**CHAPTER 11**  
**REQUEST FOR WAIVER FROM ACCESSIBILITY REQUIREMENTS**  
**CHAPTER 553, PART V, FLORIDA STATUTES**  
**August 1999**

MODIFICATION PER  
ADA CODE REQUIREMENTS  
CHANGE OF USE

**SLIP N' SLIDE RECORDS**  
919 4TH STREET  
MIAMI BEACH, FL 33139

DATE:	FULLTON J. SALAZAR	DRAWING NO.:	03-2510C-1
ARCHITECT:	44760000209	SHEET:	C-1
3571 HALEAH DRIVE			
HALEAH, FLORIDA			
PHONE: (305) 888-5682

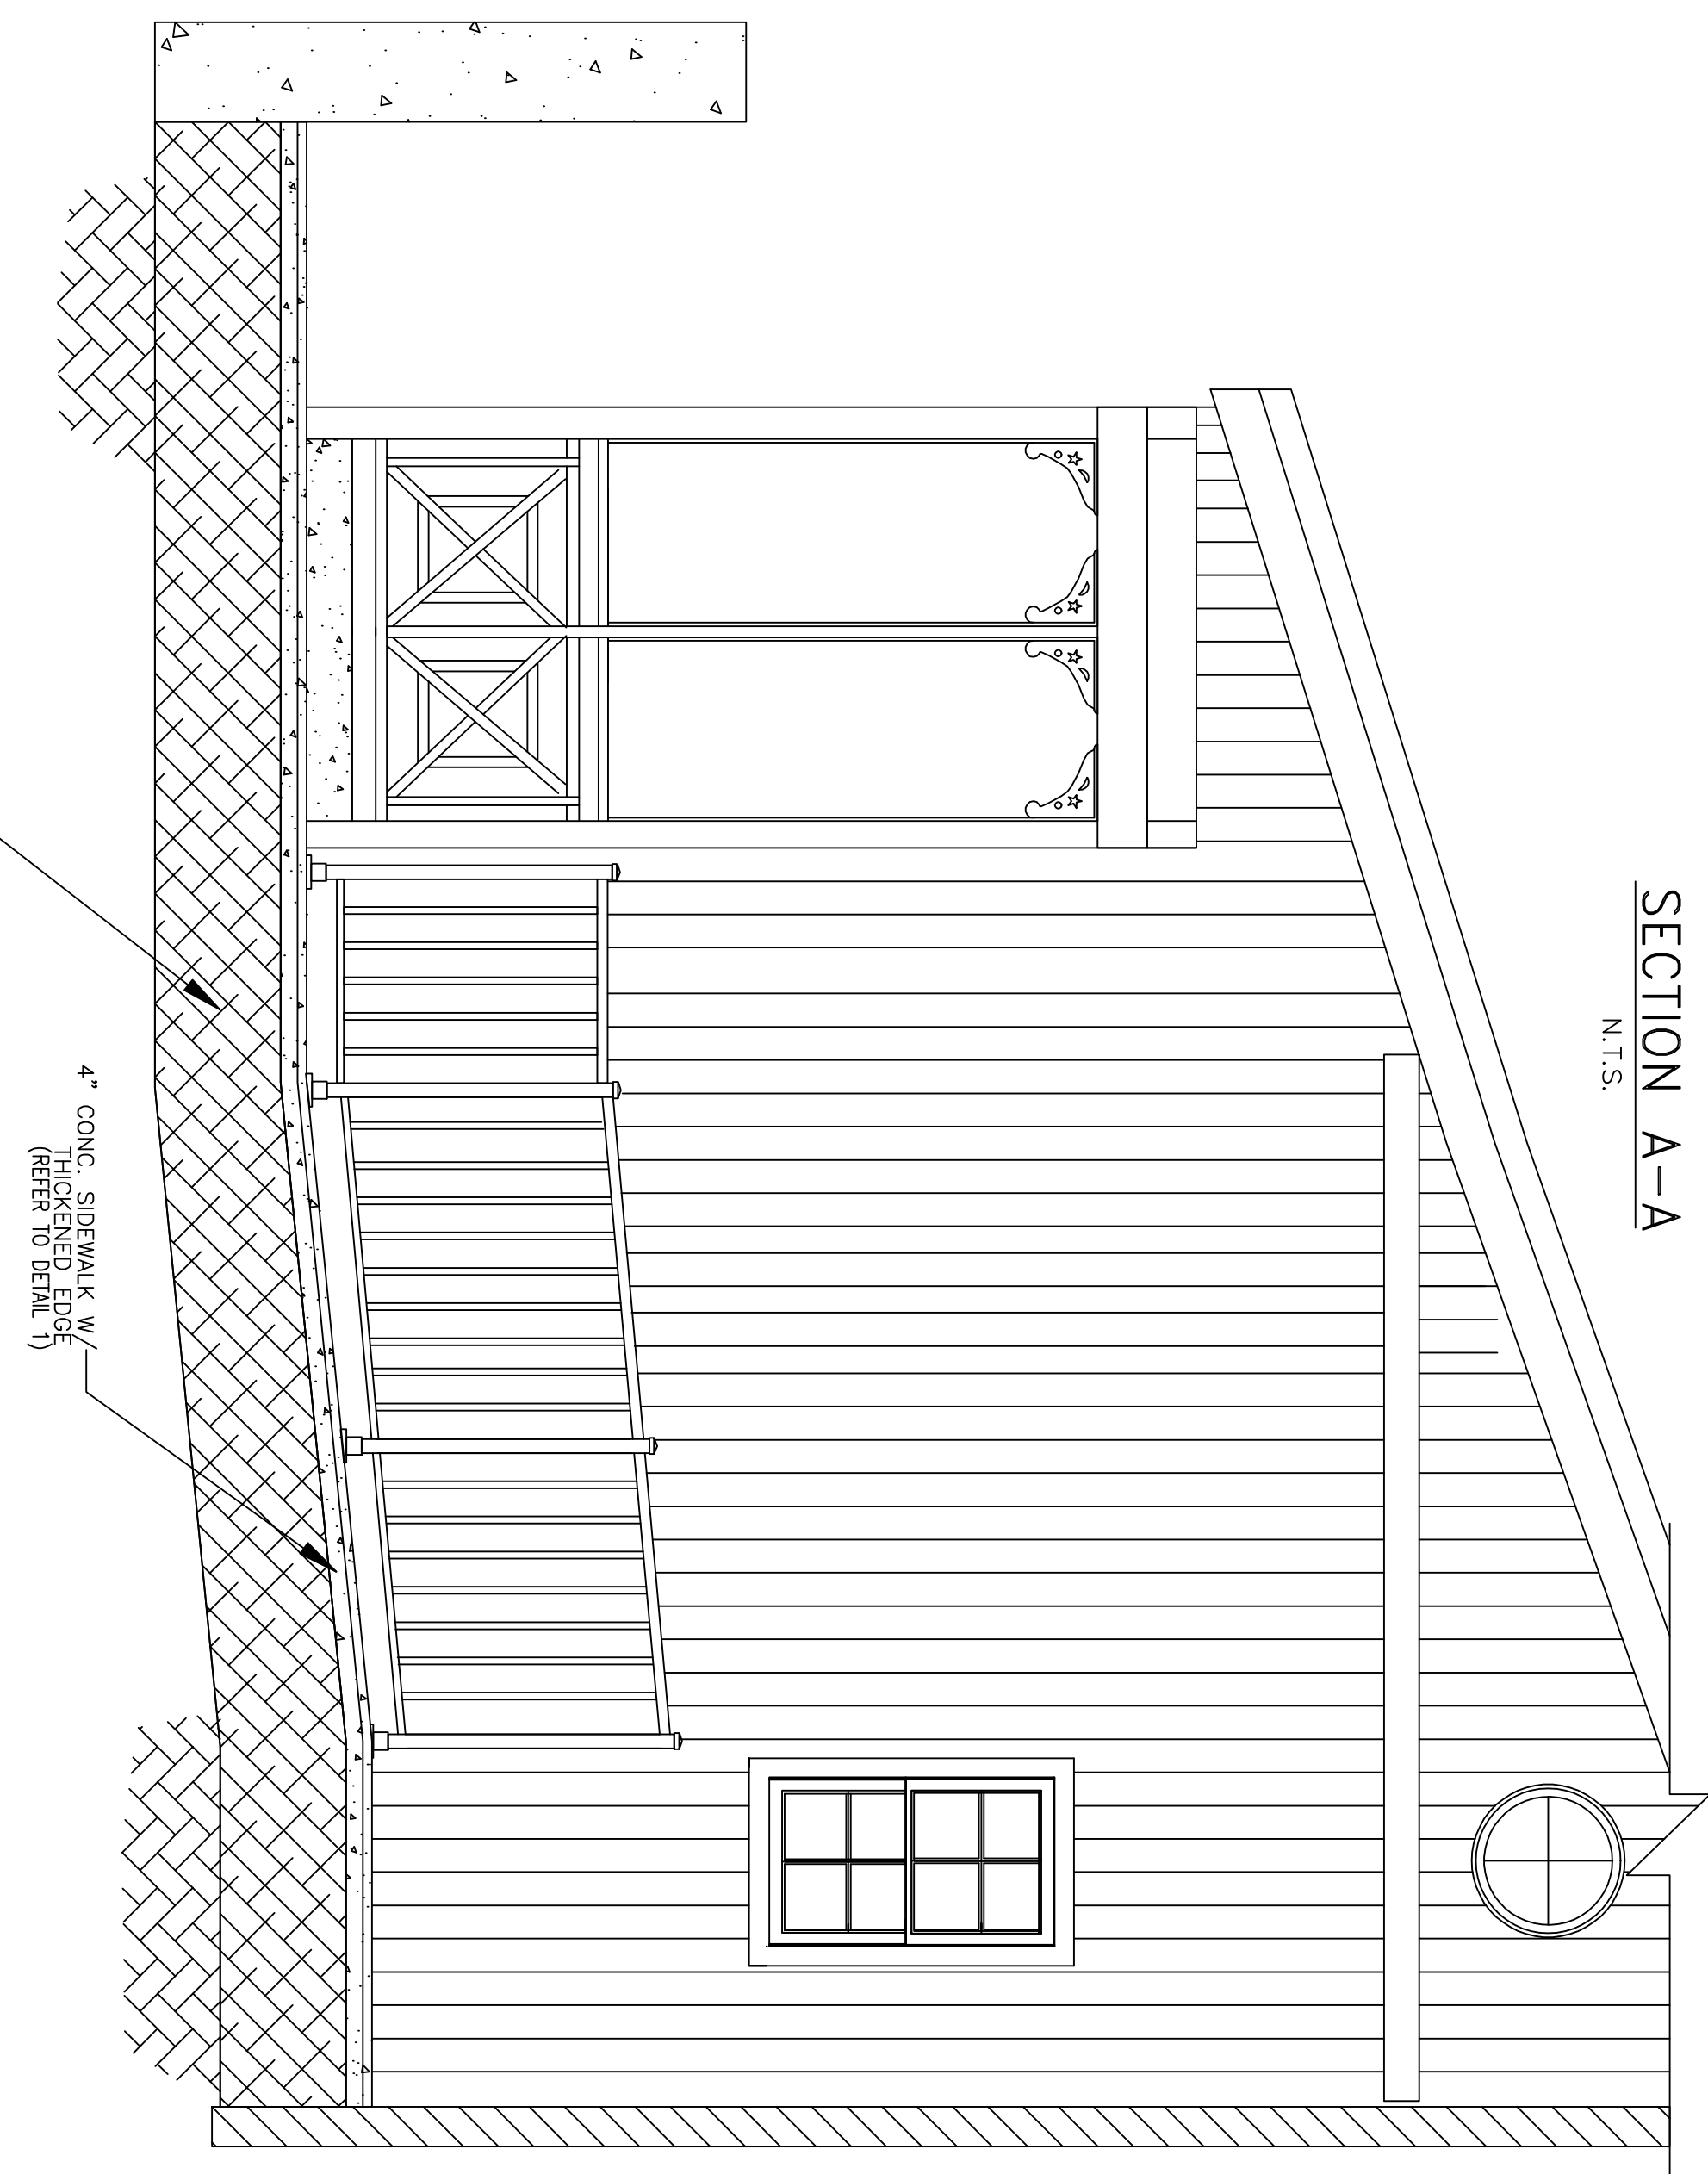
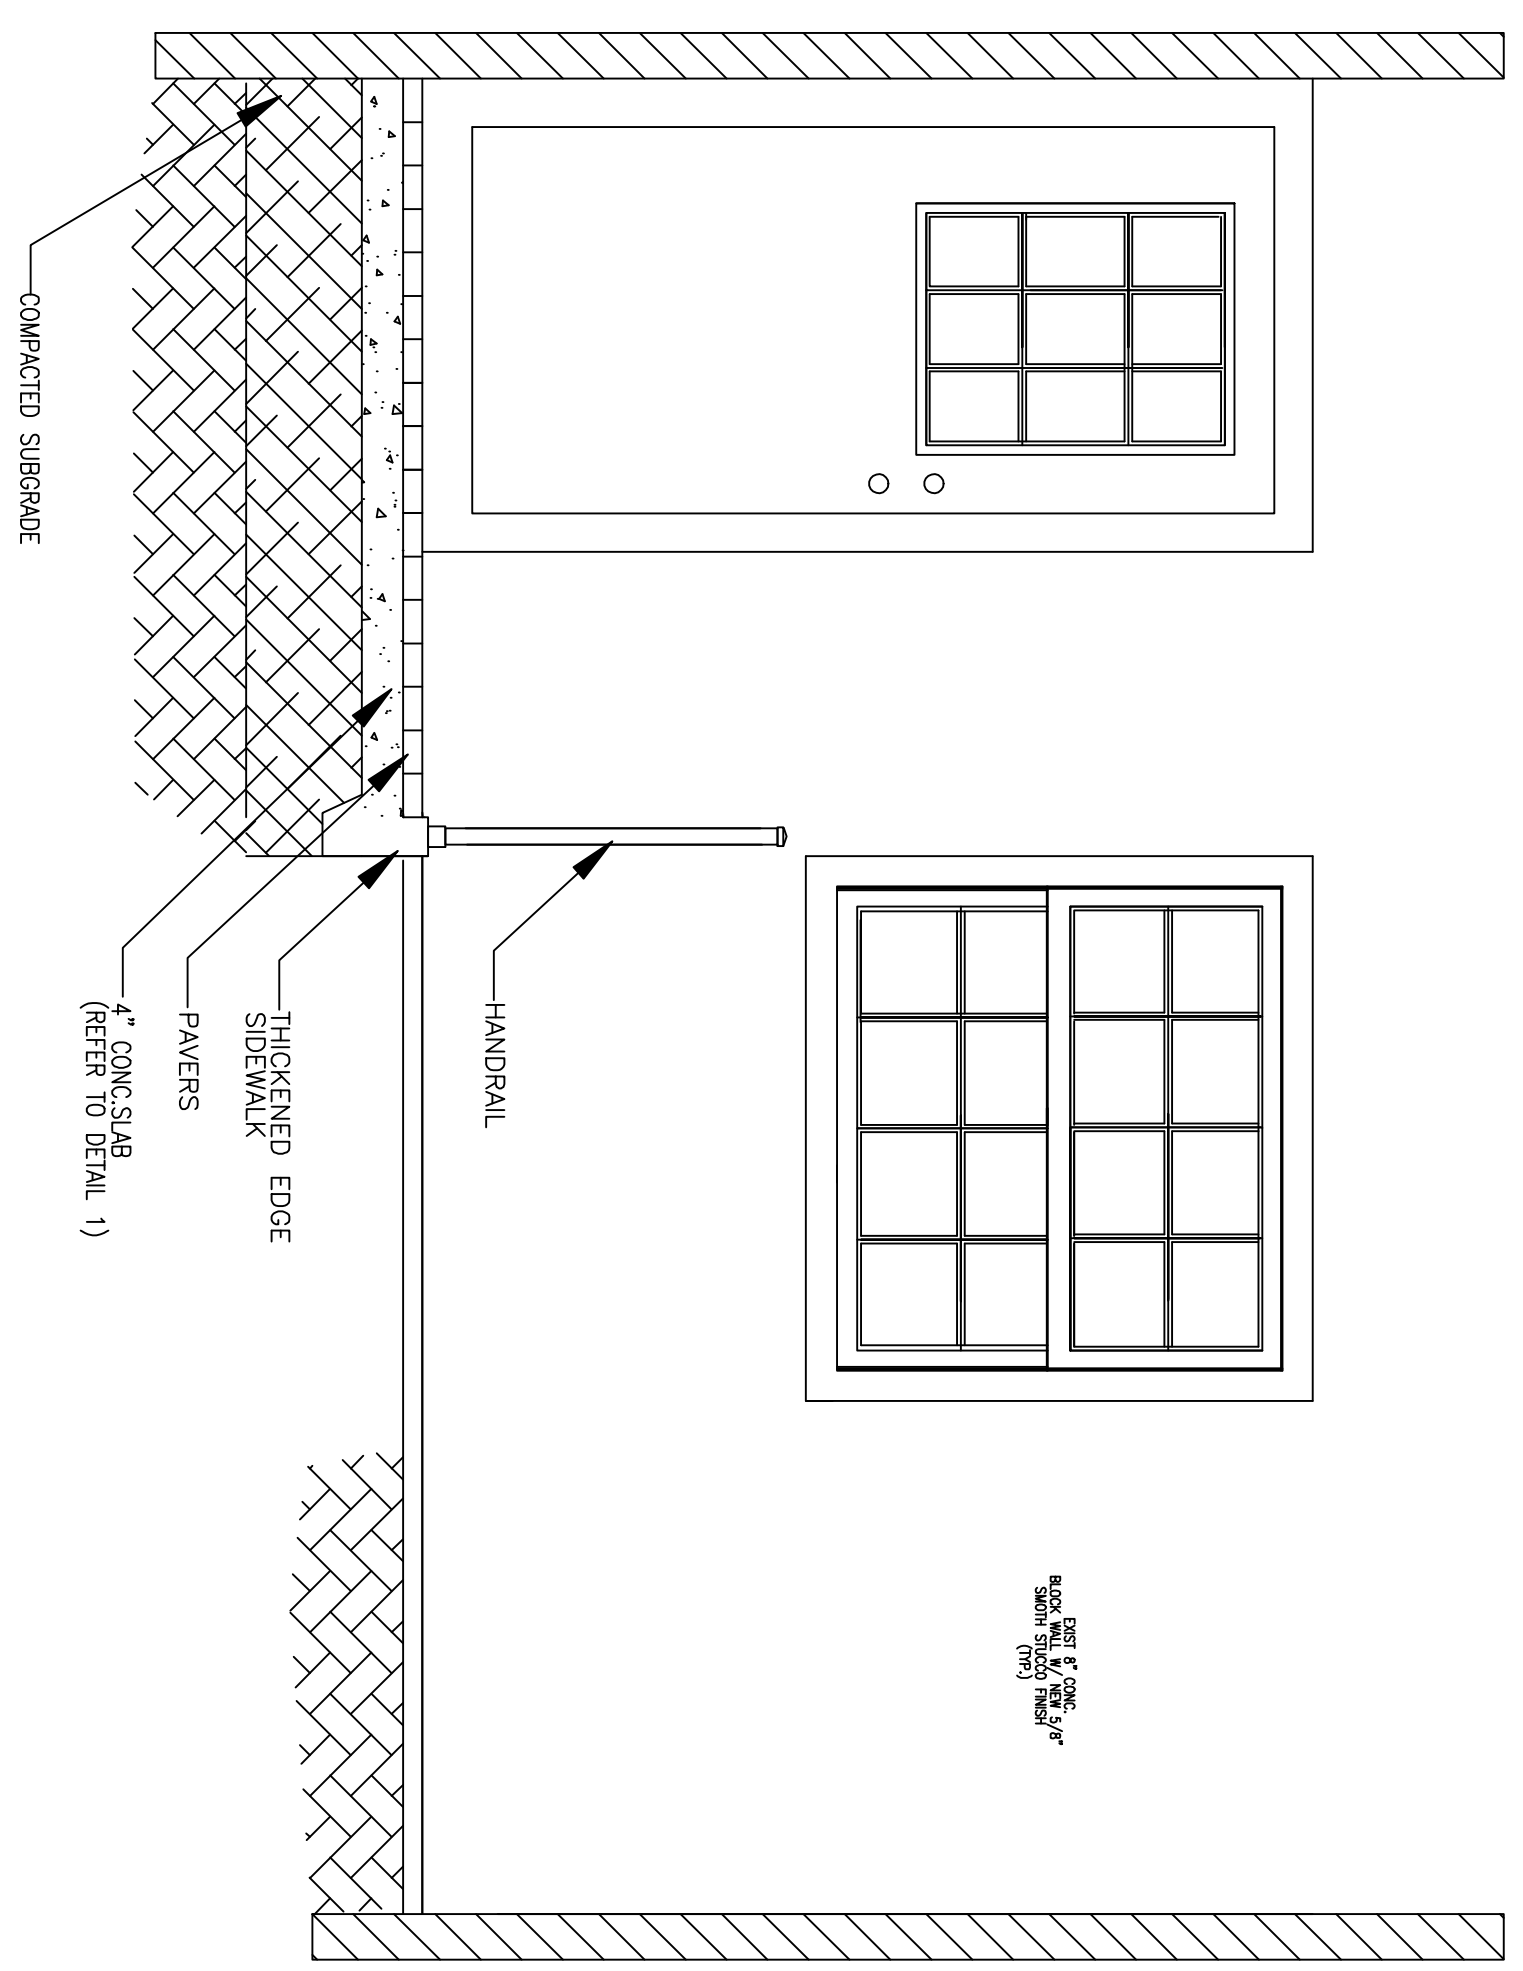
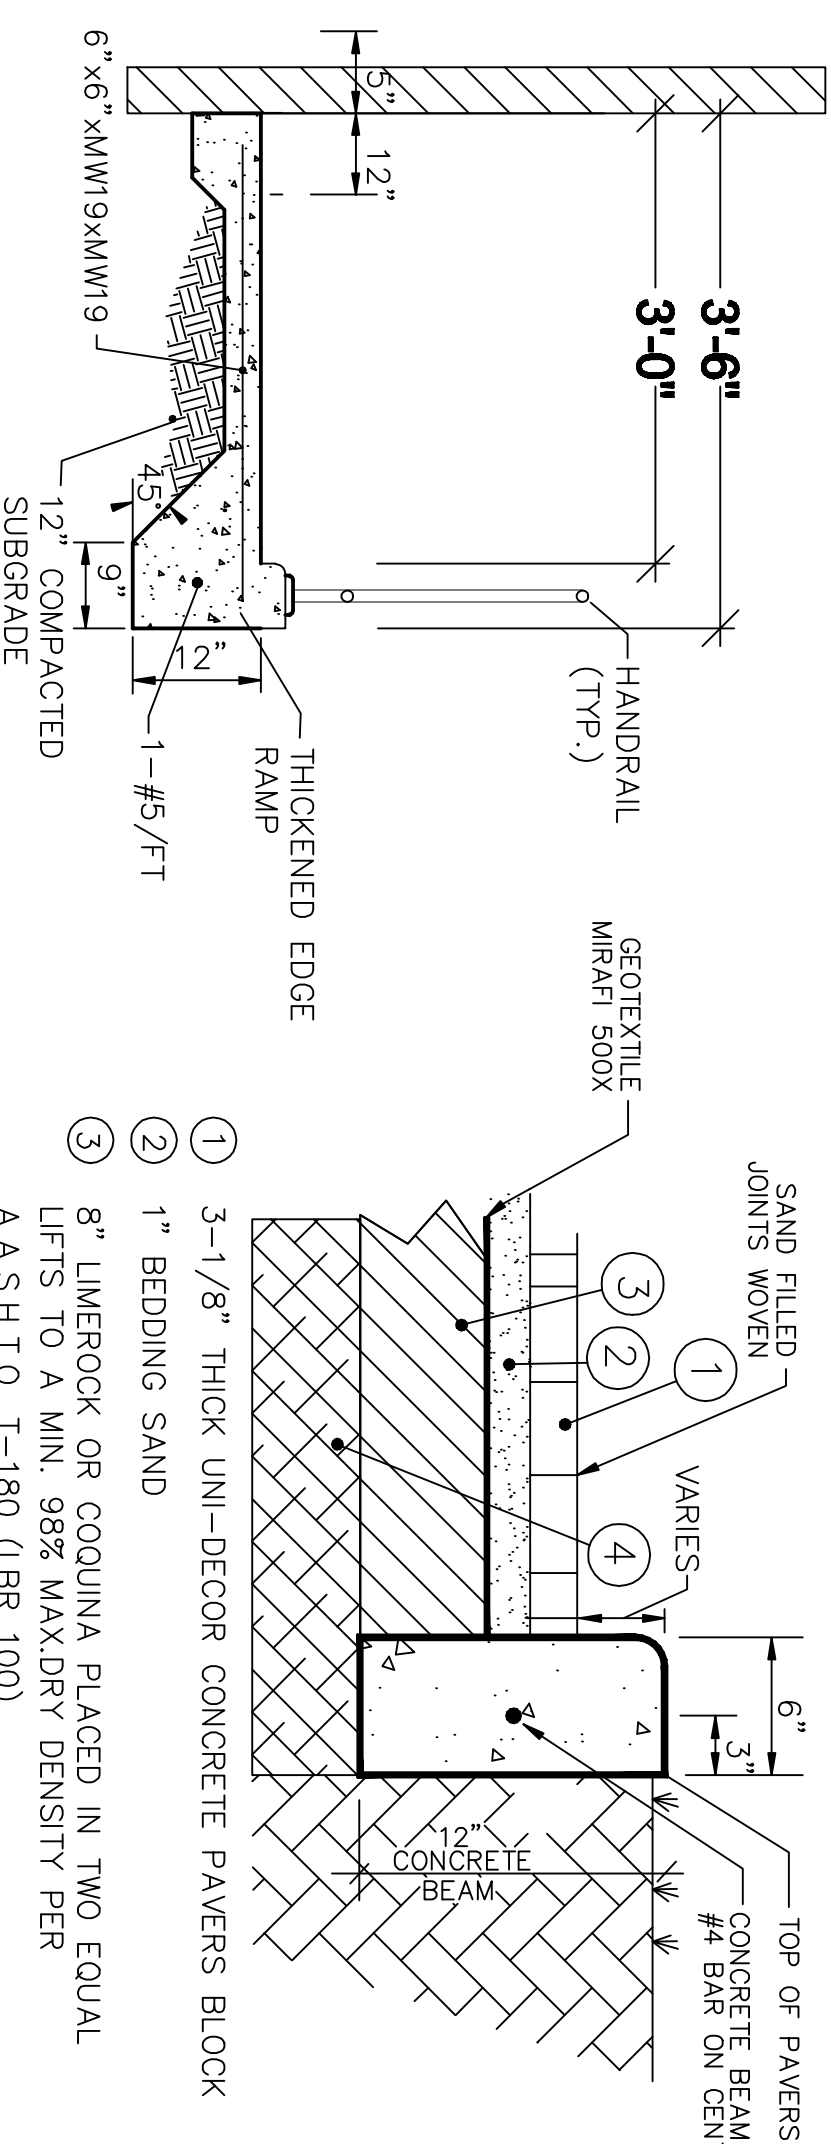
Site plans are still insufficient, sheets A1 and A2 do not show entire site and property lines. Please

modify site plan to include the property lines, setback distances to property lines, remove unnecessary hatching and grassing which confuses the drawing, demonstrate clearly the where the ramp is and where the landings are, and where the railings are. Show dimensions of proposed paving.
